PRCOM20224906

REVISDE 6/22/2023

I-470 BUSINESS & TECHNOLOGY CENTER, LOT 7

ISSUED FOR PERMIT OWNER REVISIONS

SITE STORM DRAINAGE PLAN AND CALCULATIONS

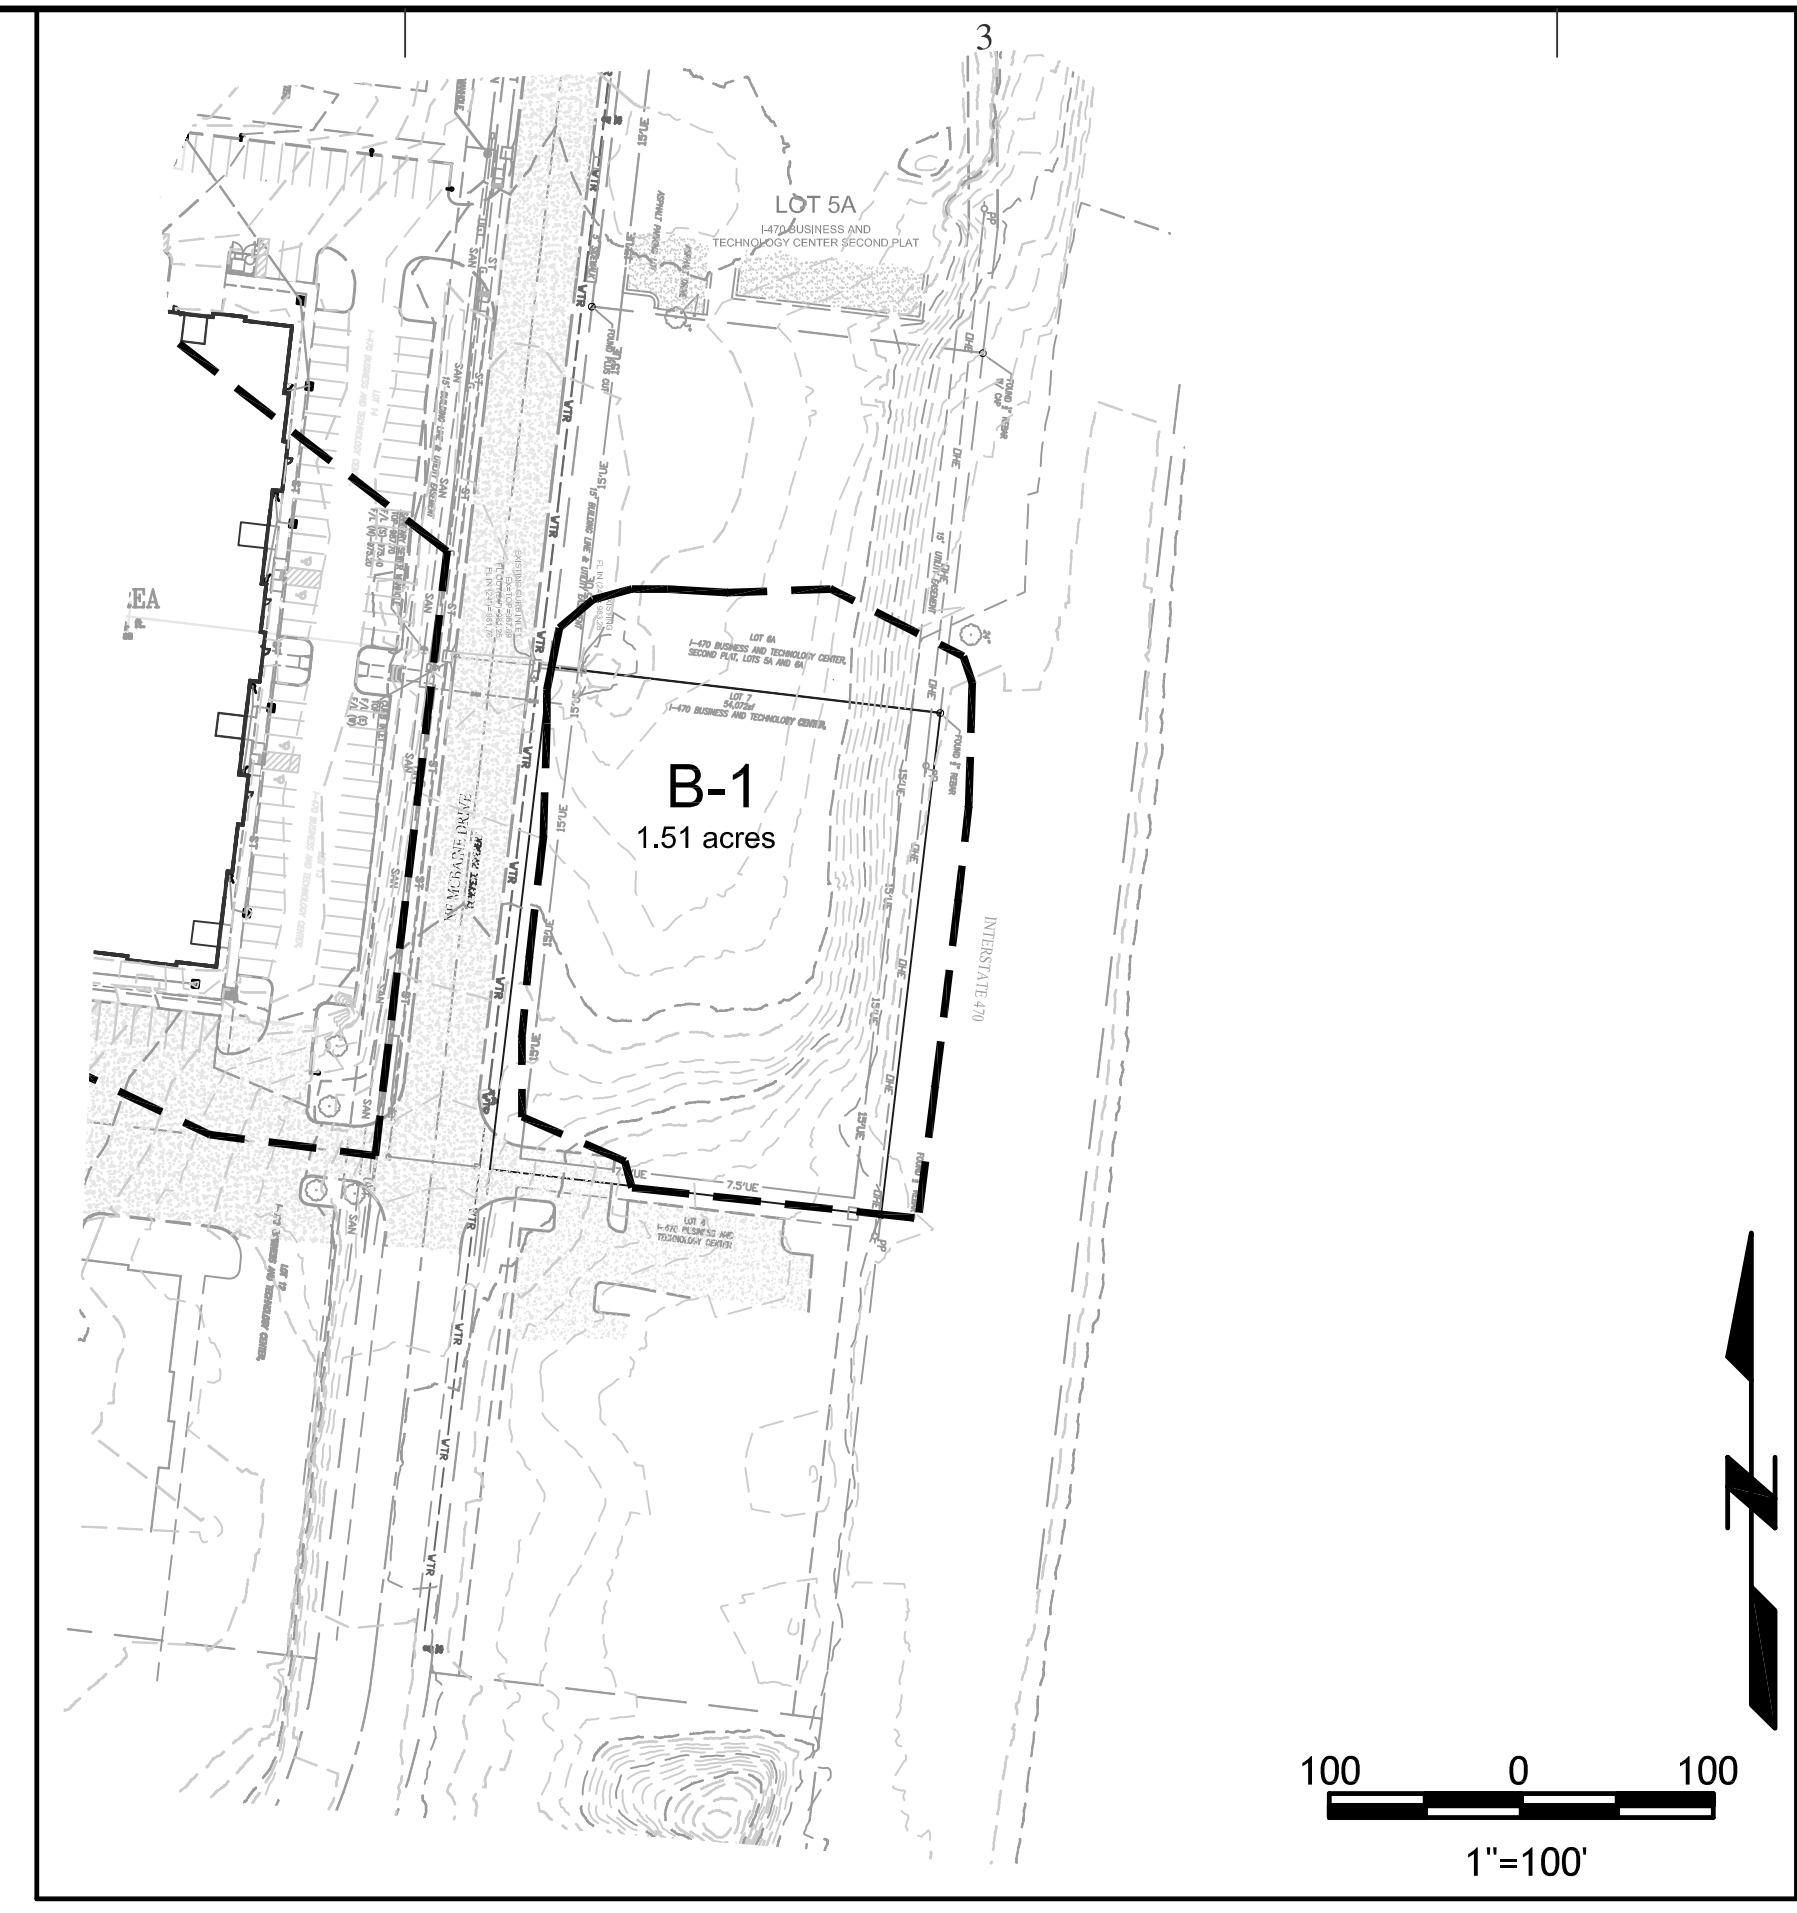
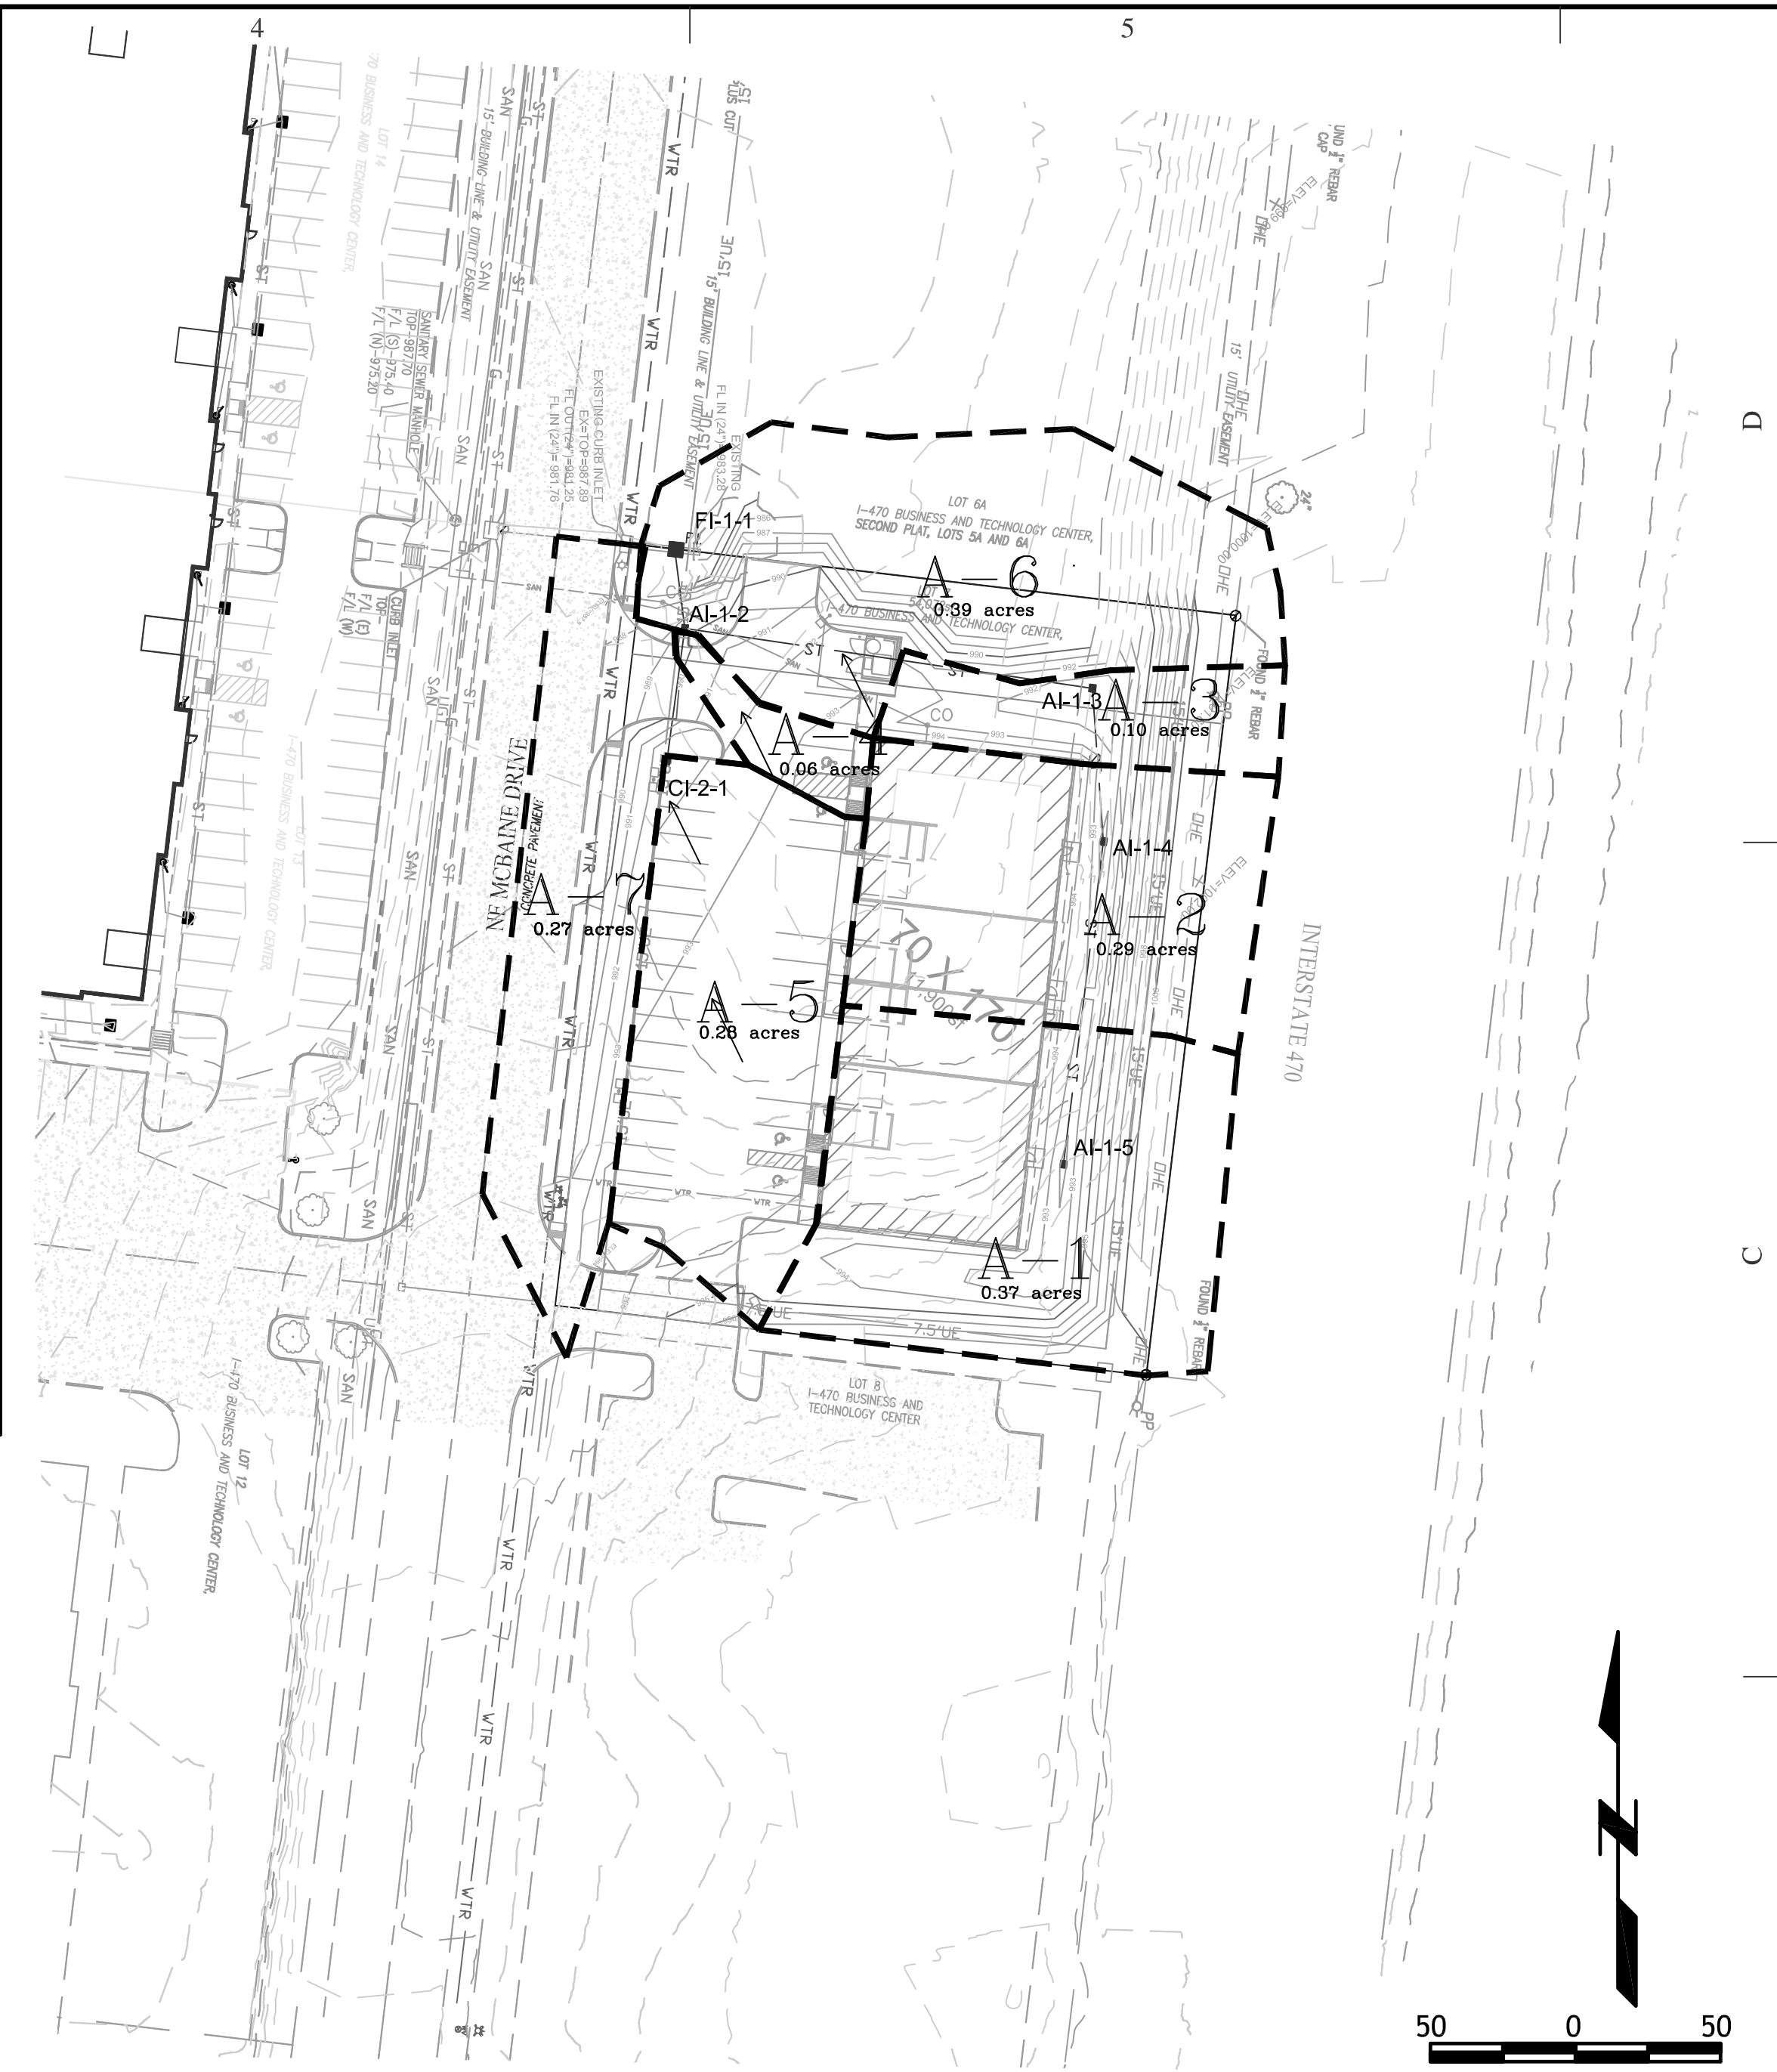
6-22-23 - REMOVED REAR ACCESS ROAD, RELOCATED TRASH ENCLOSURE REVISED PARKING ALONG FRONT OF BUILDING
